Project	IEEE 802.16 Broadband Wireless Access Working Group < http://ieee802.org/16 >	
Title	Add “sub-segment” to the PUSC mode	
Date Submitted	2004-11-04 15 16	
Source(s)	John Lee, Gang Yu, Yongmao Li HUAWEI No.98, Lane91, Eshan Road, Pudong Shanghai, P.R. China, 200127	Voice: 86-21-68644808 Fax: 86-21-50891851 mailto: John_Lee@huawei.com yug@huawei.com lymao@huawei.com
Re:	Contribution on comments to IEEE P802.16e/D5	
Abstract	<p><u>In the current specification, sub-channels are divided and assigned to three segments in PUSC mode that can be allocated to three different sectors of the same cell, while three sectors may not be enough to deploy a single carrier cellular network, considering co-channel interference problem to FCH, DL/ULMAP. We propose to add “sub-segment” to the PUSC mode. One segment is divided into 3 sub-segments. BS transmits FCH and DL/ULMAP on the sub-channels of one sub-segment, thus we have 9 different frequency positions to avoid co-channel interferences. According to the current OFDMA PHY Specification, subchannels are divided and assigned to three segments in PUSC mode that can be allocated to three different sectors of the same cell. While three sectors a

Figure 220 FCH subchannel allocation for all 3 segments

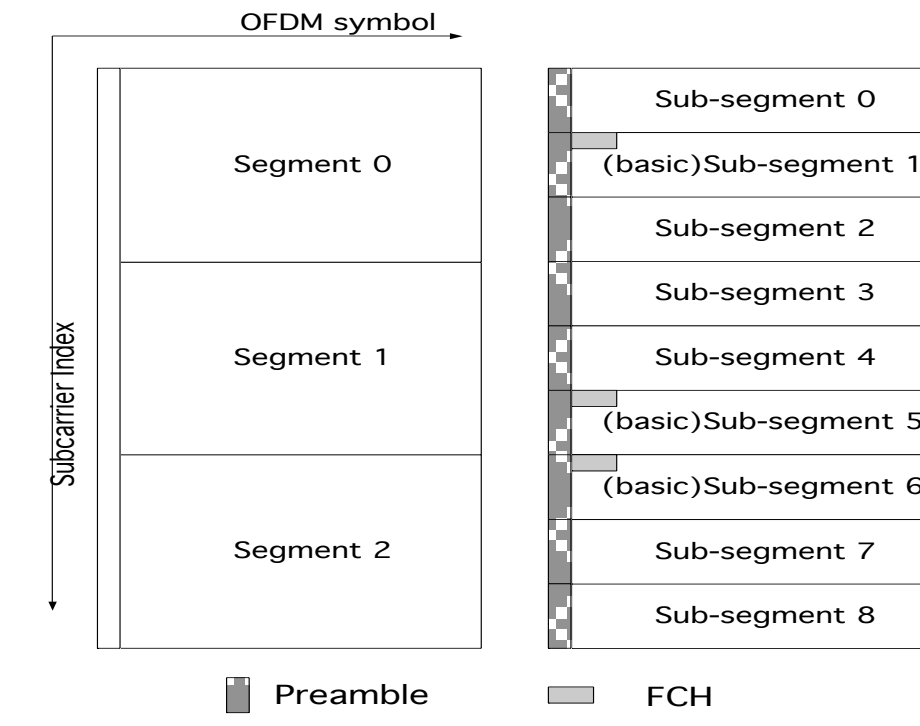
[Change the 8.4.4.4 as follows]

8.4.4.4 Allocation of subchannels for FCH, and logical subchannel numbering

In PUSC, any sub-segment used shall be allocated at least 12 subchannels. The first 4 slots in the downlink part of the basic sub-segment contain the FCH as defined in 8.4.4.2. These slots contain 48 bits modulated by QPSK with coding rate 1/2 and repetition coding of 4. Figure 220 depicts this structure.
